Product Change Notification

Change Notification #: 113371-00
Change Title: Intel® Compute Module HNS2600WPF
PCN 113371-00, Product Design
Change the material of tray latch cap from
rubber to polycarbonate
Date of Publication: November 3, 2014

Intel is implementing the following change on the Intel® Compute Module HNS2600WPF:

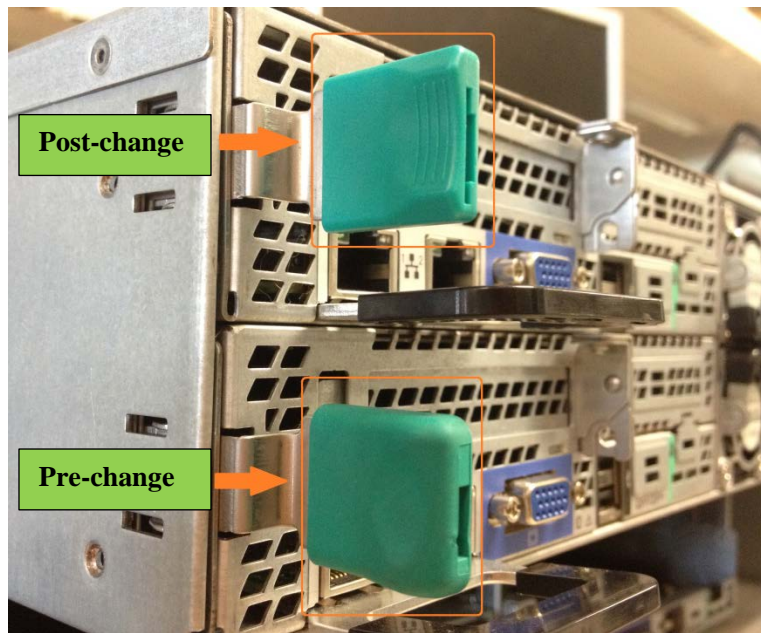
Change the material of tray latch cap from rubber to polycarbonate to avoid pulling the cap out from the tray latch.

See below picture: the lower one is pre-change cap and the upper one is post-change cap.
